DA2020/0432

9-11 Birdwood Avenue Collaroy

Construction of a Seniors Housing or Housing for Persons with a Disability and Strata Subdivision

Development Determination Panel (DDP) for determination on Wednesday, 11 November 2020 at 10.00am.

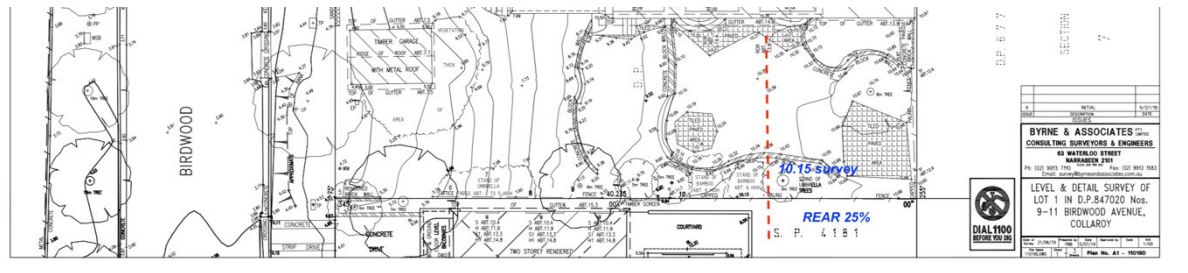
Comment:

The SEPP HSPD 'Rear 25%' of the proposed development still represents a two-storey volume, as the floor below is still more than 1m above ground level existing.

SEPP control, Part 4 Division 40(c) of the SEPP that states: *"a building located in the rear 25% area of the site must not exceed 1 storey in height. "*

The proposed reduction to RL 11.40, is set against a surveyor's spot level to the western side at **10.15**. [see attached part survey]

To accord with the SEPP HSPD we ask for

"A reduction of the upper ground floor level to be reduced to **RL 11.15**, with the upper roof level to be no higher than **RL 14.15** and with no element of the roof to be above **RL 14.15**"
